Portland General Electric Company
Trojan ISFSI
71760 Columbia River Hwy
Rainier OR 97048

**Transmittal of Revision 7 to the Trojan Independent Spent Fuel
Storage Installation (ISFSI) Emergency Plan, PGE-1075**

Changes Incorporated into Revision 7 to the Trojan ISFSI Emergency Plan, PGE-1075

LDCR 2006-0002

FIGURE 1-3
ISFSI CONTROLLED AREA BOUNDARY

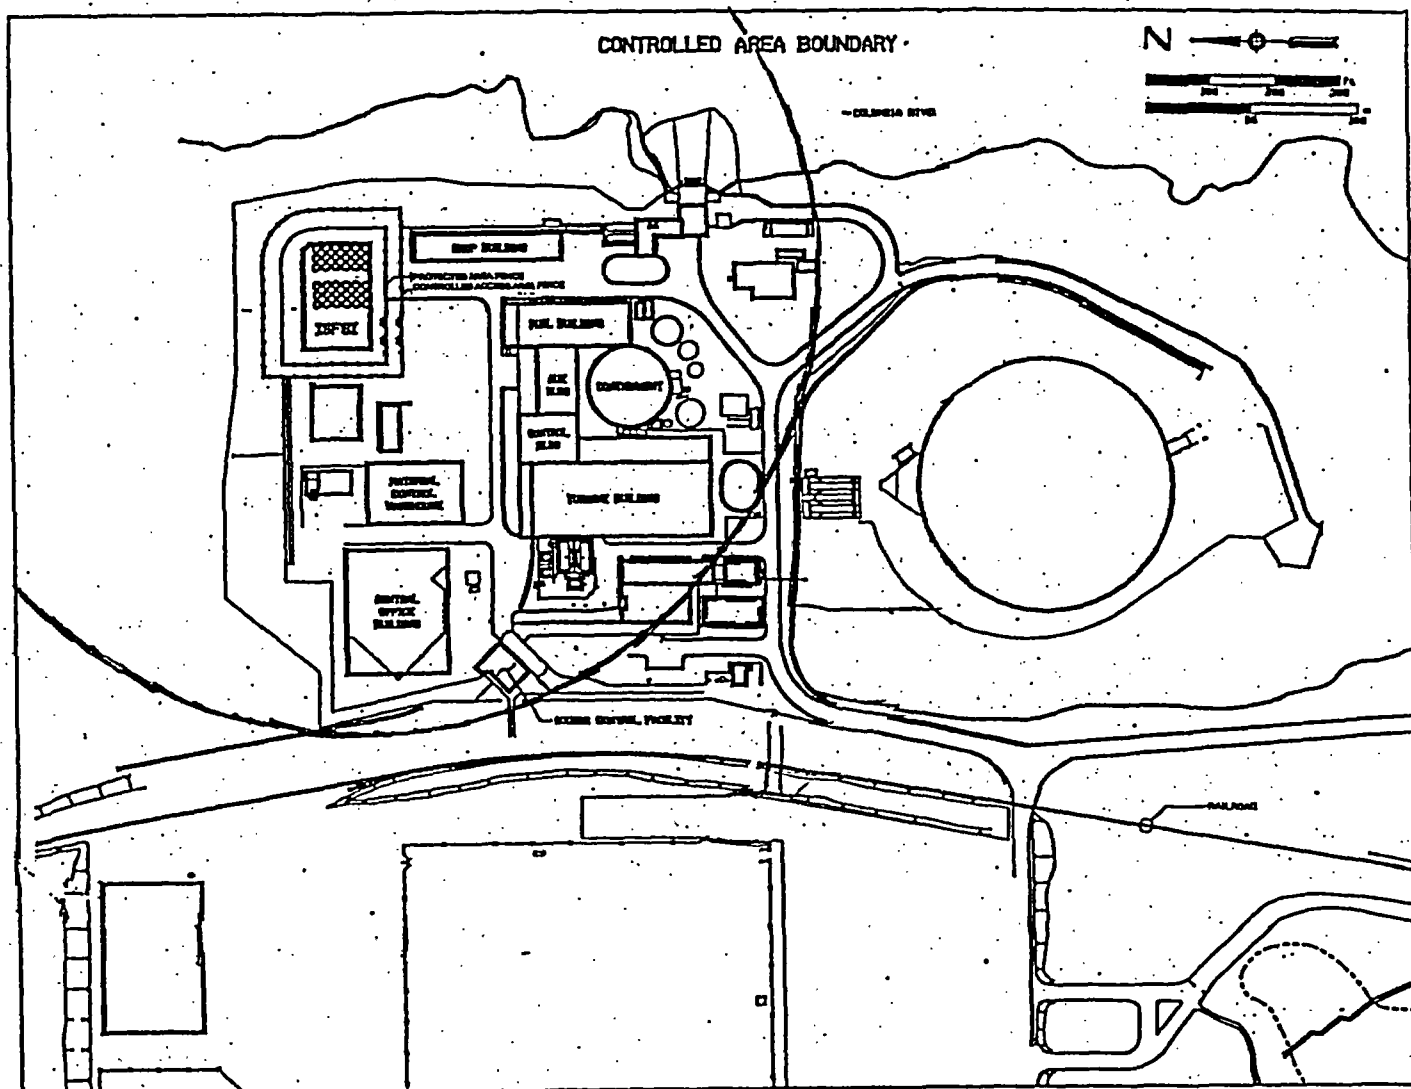
1. Section 1.2 - Changed 300 meters to 200 meters, and deleted the reference to Portland and Western Railroad right of way, as the railroad track is no longer within the CAB.
2. Section 2.2 - Changed position title "Shift Manager" to "ISFSI Manager".
3. Section 4.4 - Deleted the references to Portland & Western Railroad right of way and rail traffic control.
4. Appendix – Agreements. Deleted agreement with Portland & Western Railroad, Inc.
5. Figure 1-2, "Location of the Trojan ISFSI at the PGE Site," changed to show 200 meter CAB line.
6. Figure 1-3, "ISFSI Controlled Area Boundary," changed to show 200 meter boundary line.

1. Deleted references to the cooling tower in Section 1.2, Section 1.4.3, and Figure 1-3, "ISFSI Controlled Area Boundary."
2. Deleted entire Section 1.4.3.5, Cooling Tower Collapse.
3. Deleted entire Section 2.1.2.10, Cooling Tower Collapse.
